1411 S Potomac
Aurora, CO 80012

Speculative Suite 430

RSN: 1834888
Permit#: 24-2467084-LT

City of Aurora Building Division
Reviewed for Code Compliance
Approved as Noted: **jlocke**
Date: **SEP 03, 2024**
2021 INTERNATIONAL CODES & 2023 NEC

MECHANICAL PLAN

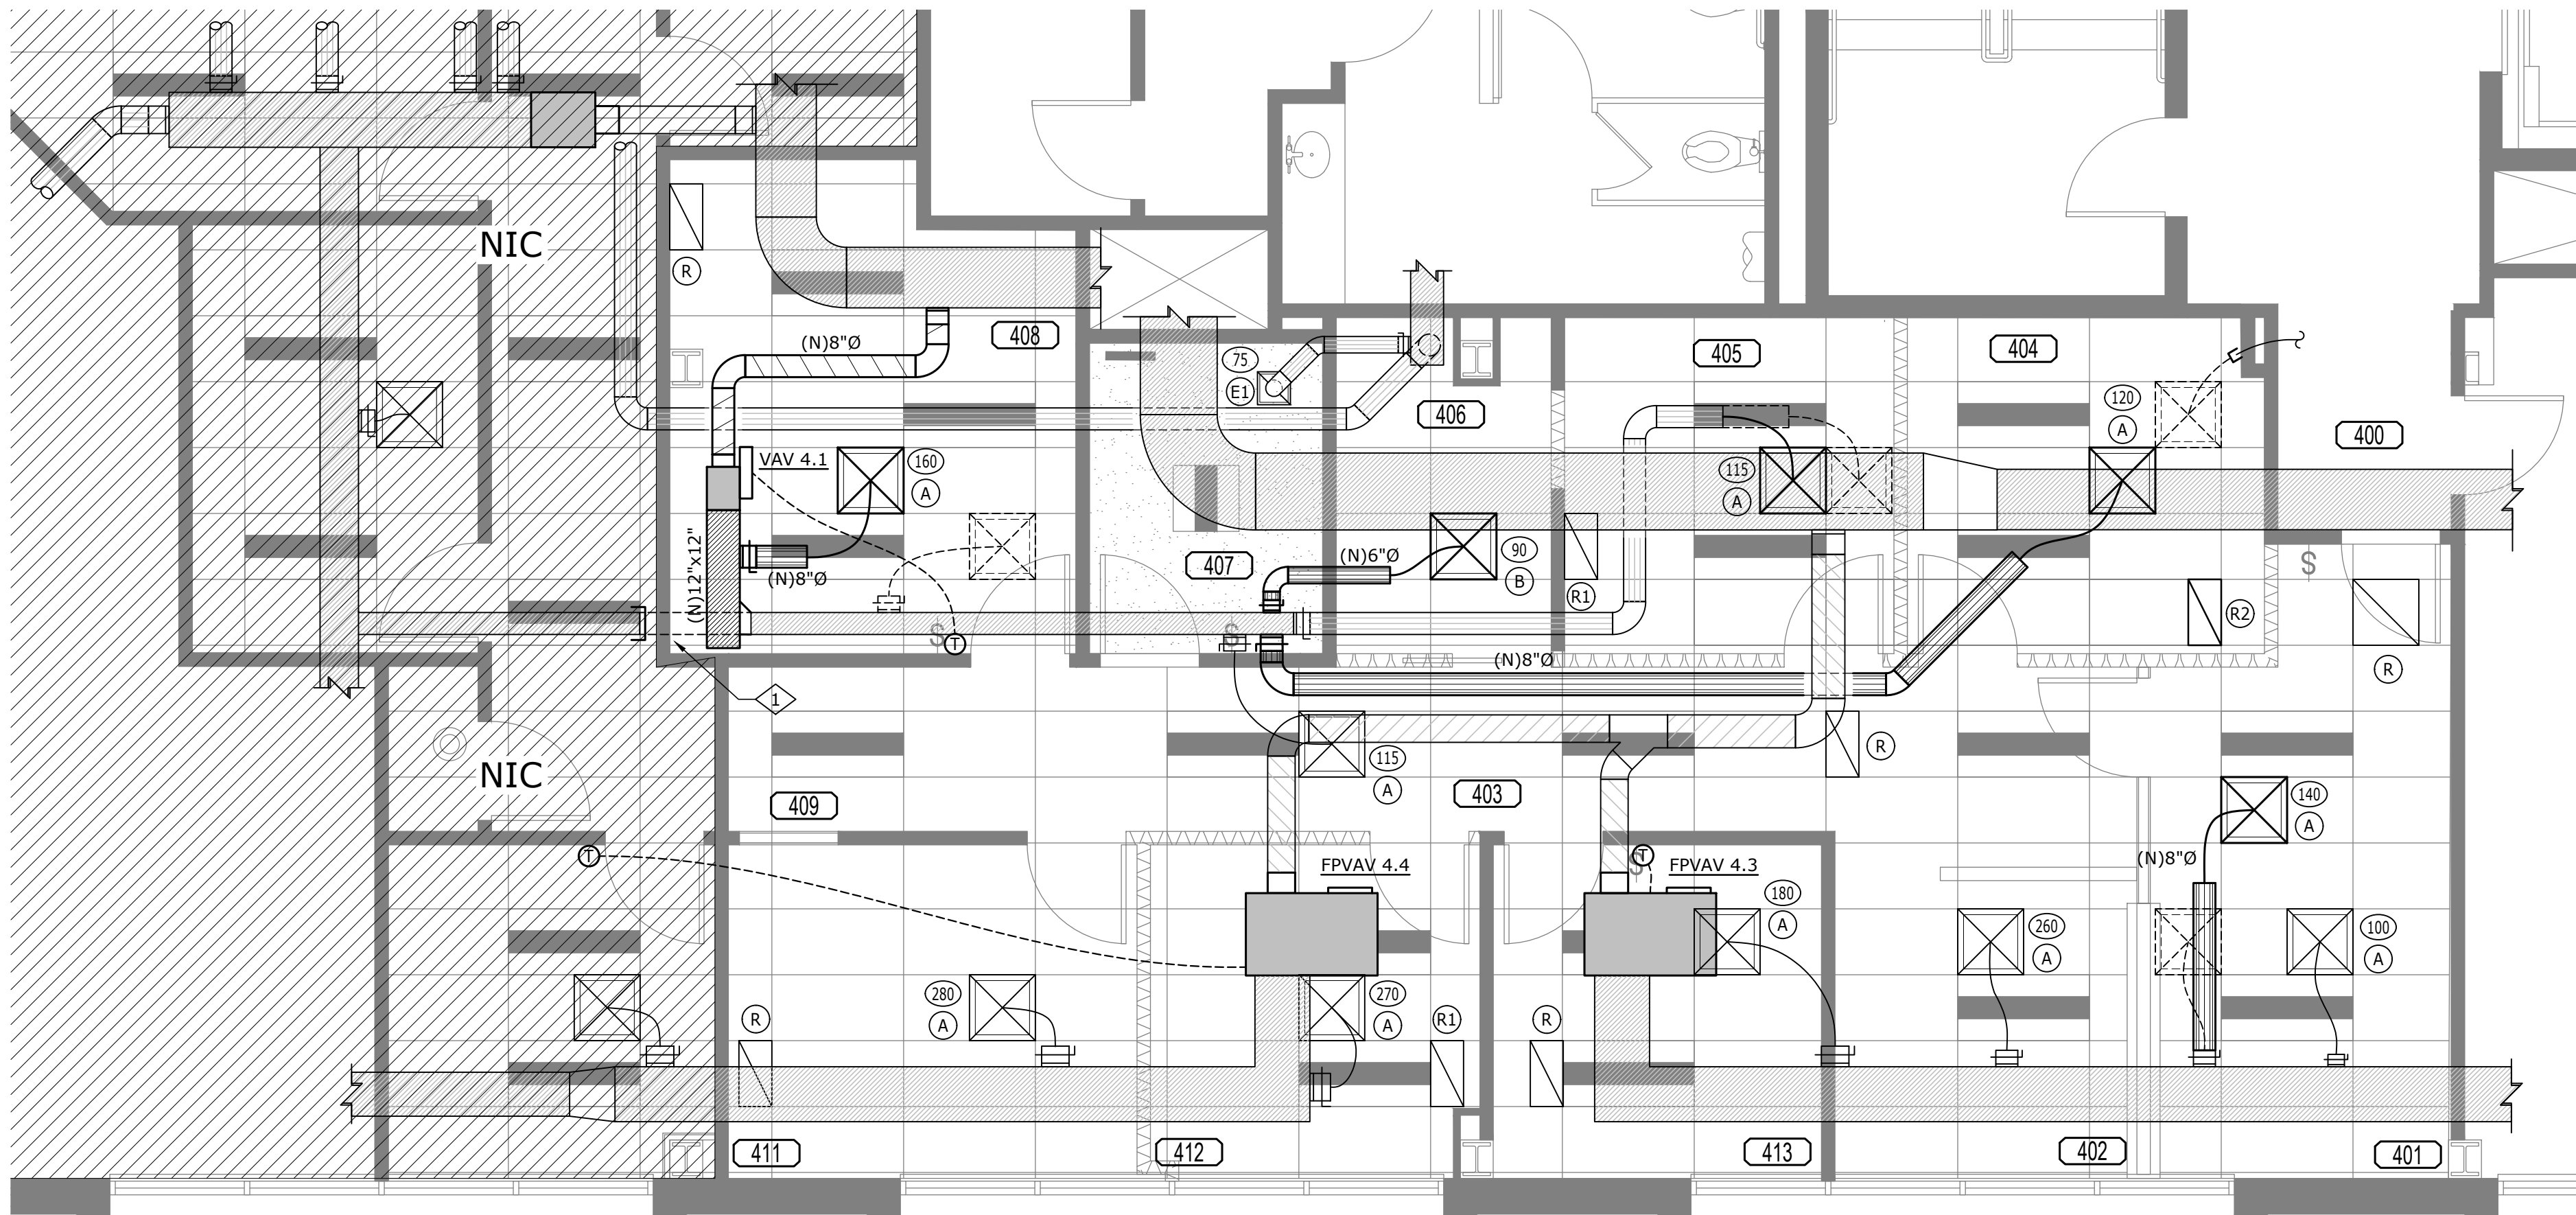
Heating system shall be capable of maintaining 68 degrees F at 3'0" above the floor.
2021 IMC 309.1, IRC 303.10 and IBC 1203.1

Provide proof of a flame spread less than 26 and a smoke development less than 50 for any material used in a plenum.
2021 IMC 602.2.1

1 PLUMBING DEMOLITION PLAN
SCALE: 1/4" = 1'-0"

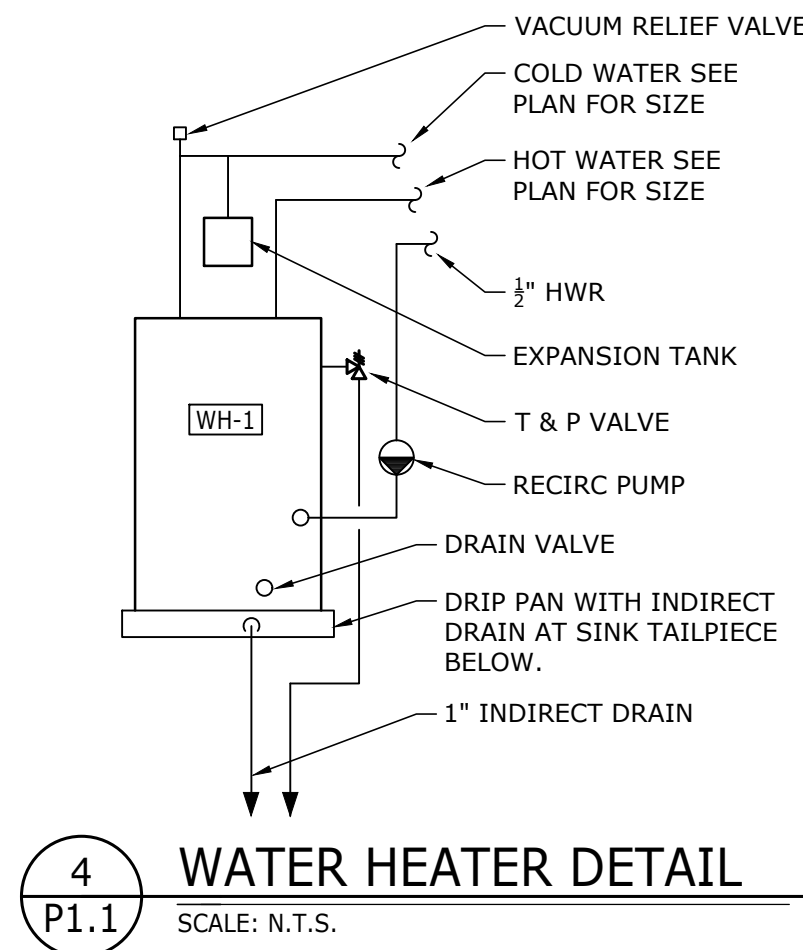
Provide Self-Closing or Meter Faucets in
Public Restrooms .2021 COA 22-326 (A)

Provide for thermal expansion on hot-
water supply system as required by
2021 IPC 607.3 or IRC 2903.4

POWER PLAN

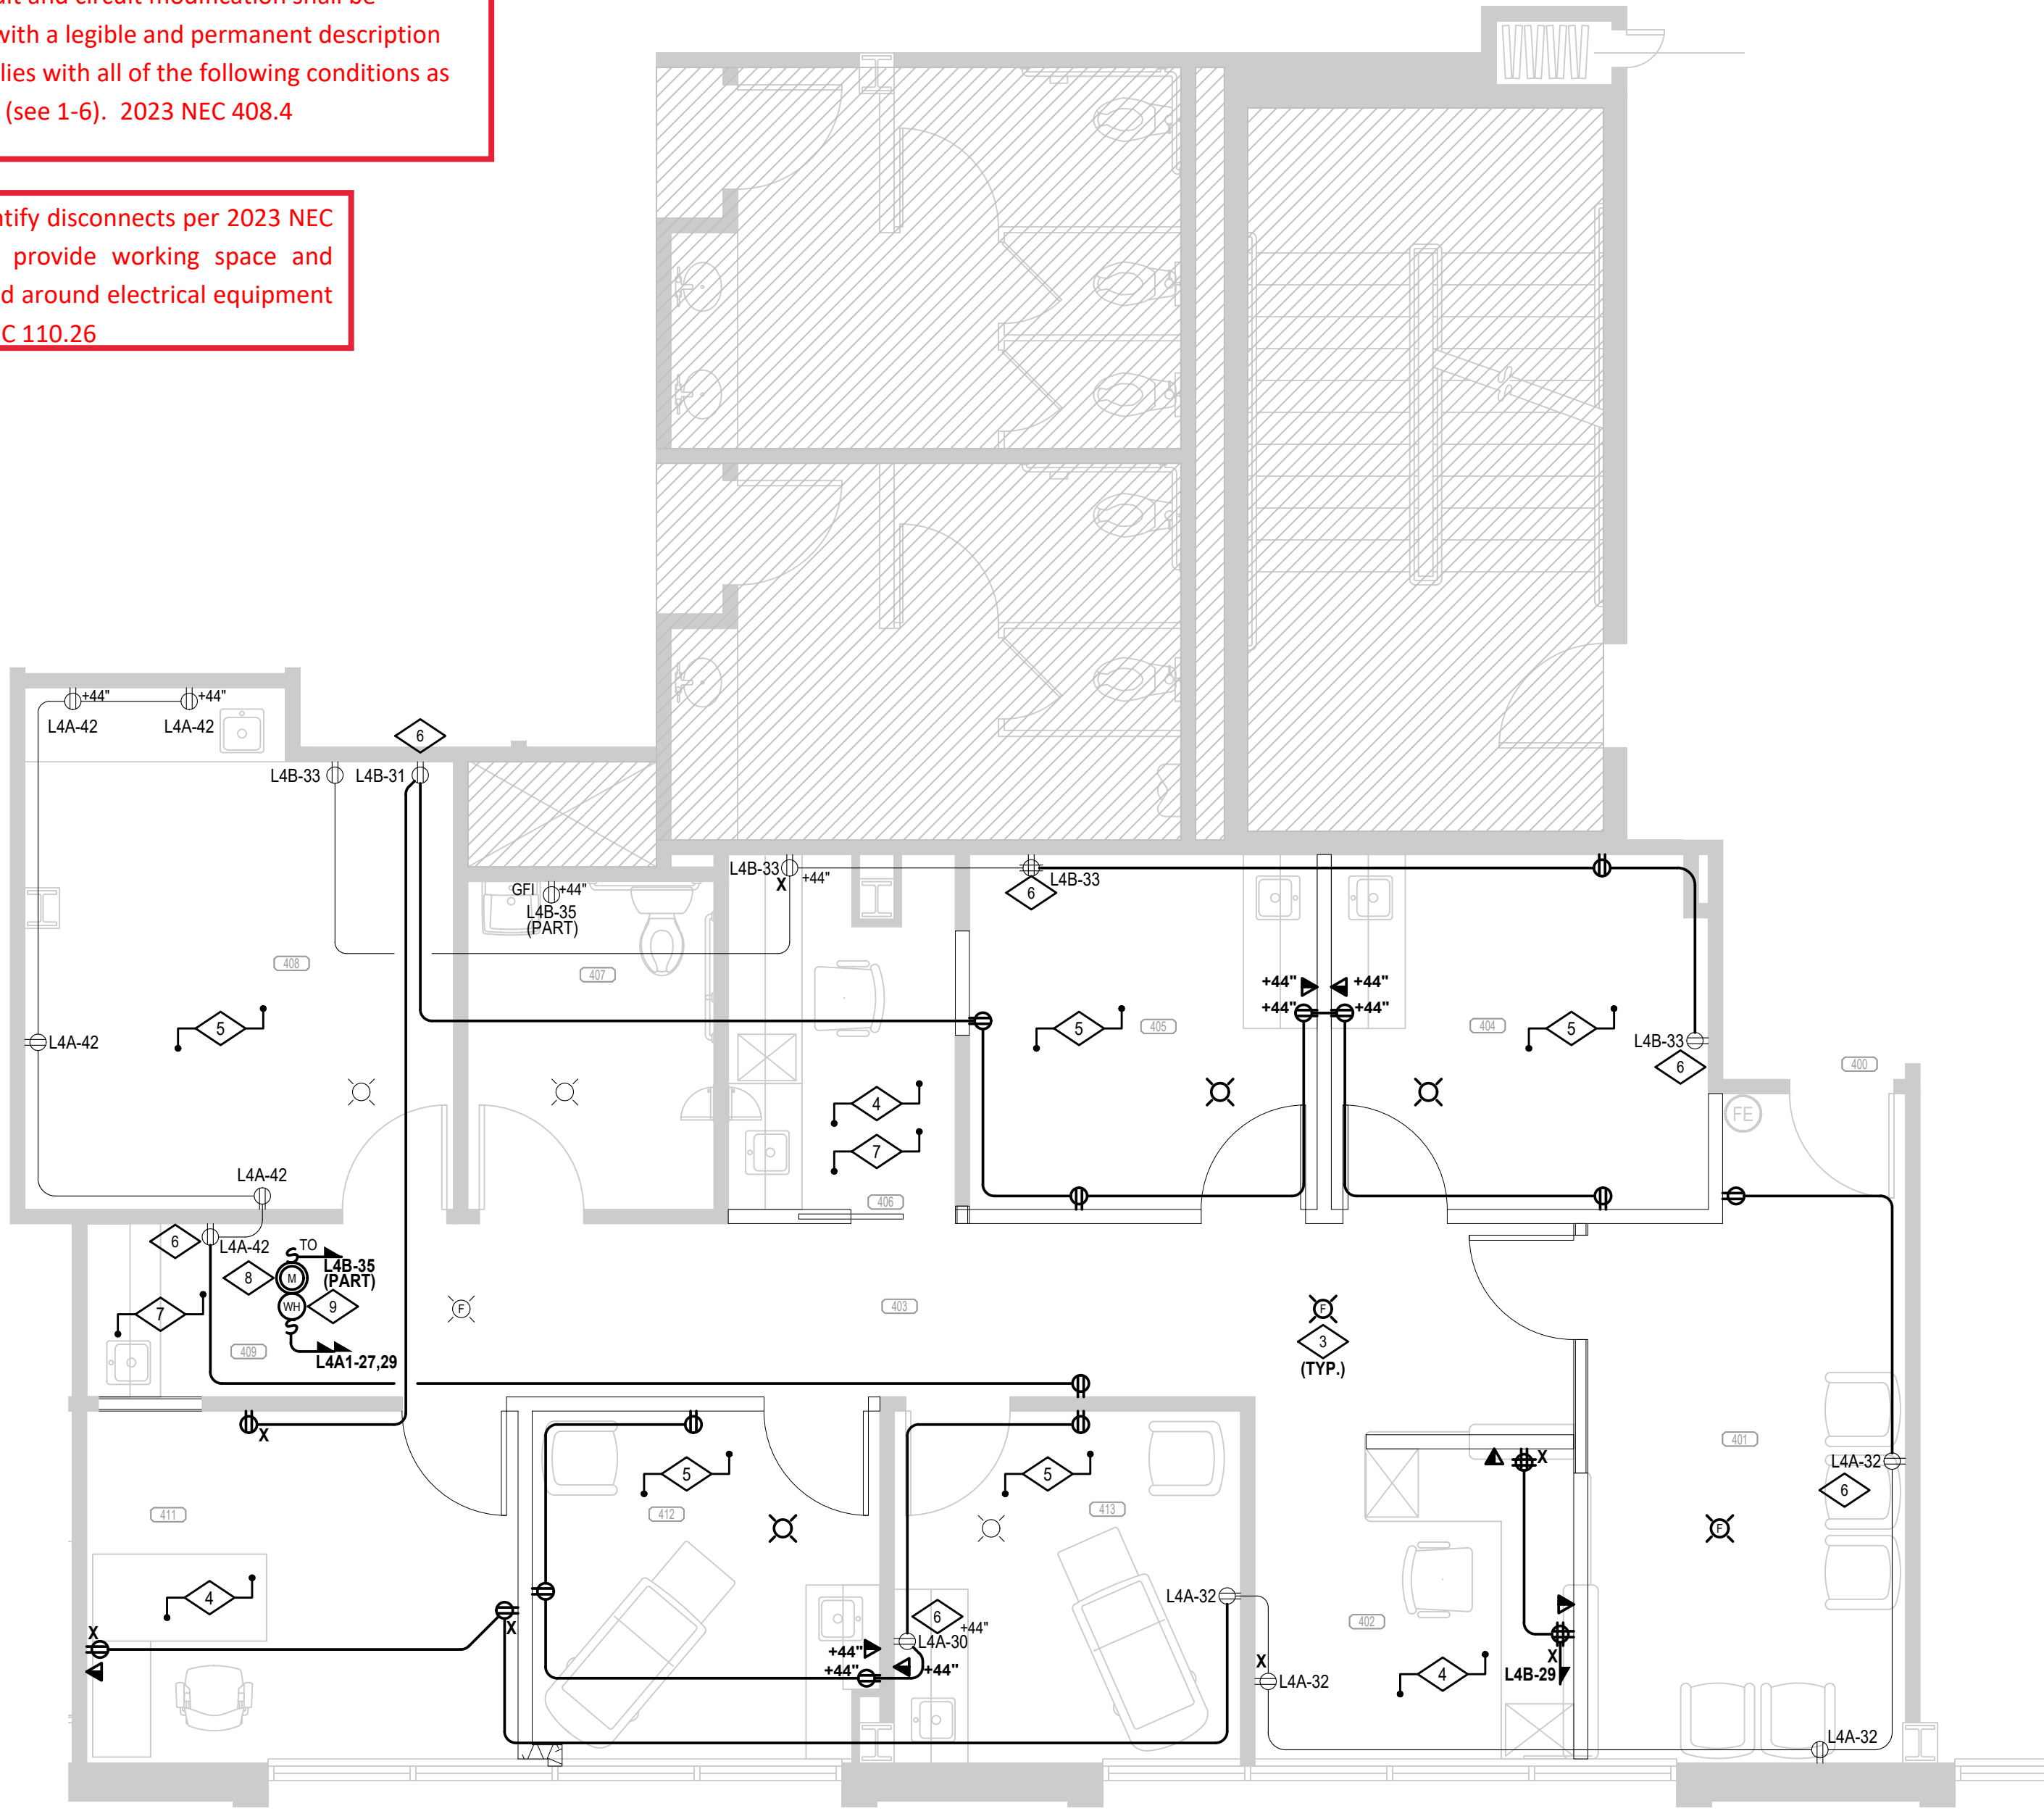
Every circuit and circuit modification shall be provided with a legible and permanent description that complies with all of the following conditions as applicable (see 1-6). 2023 NEC 408.4

110.14. Identify disconnects per 2023 NEC 110.22 and provide working space and egress to and around electrical equipment per 2023 NEC 110.26

PARTIAL EXISTING ONE-LINE DIAGRAM
SCALE: NONE (NO NEW WORK)

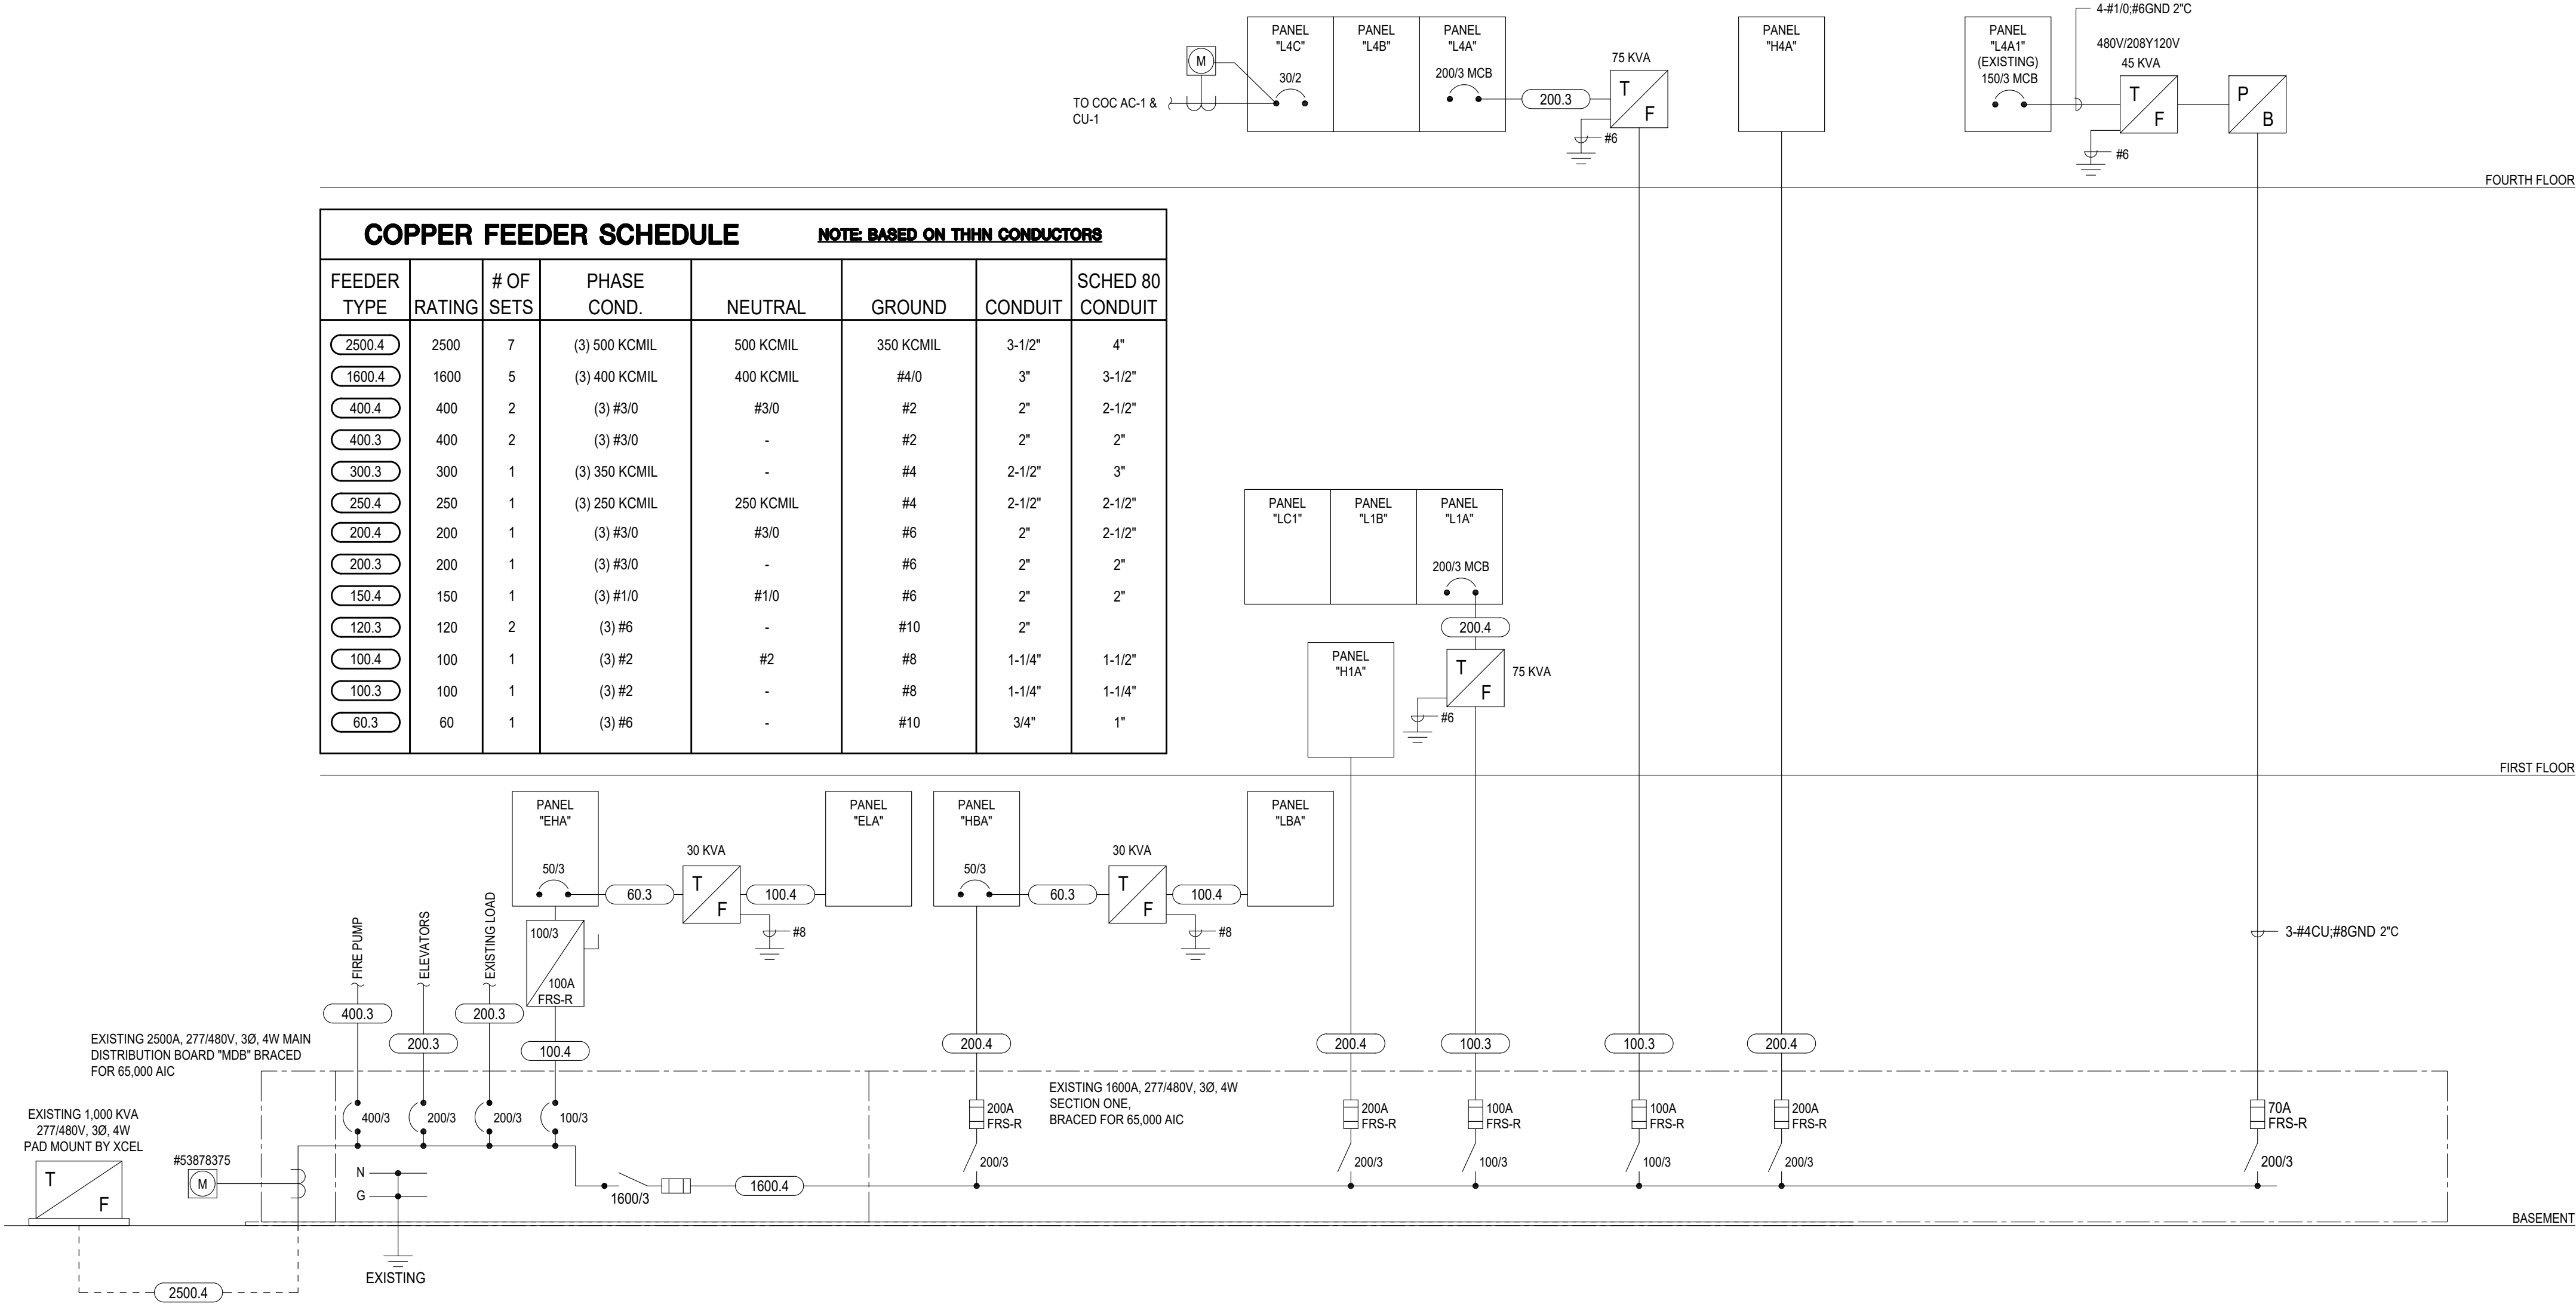
Every circuit and circuit modification shall be provided with a legible and permanent description that complies with all of the following conditions as applicable (see 1-6). 2023 NEC 408.4
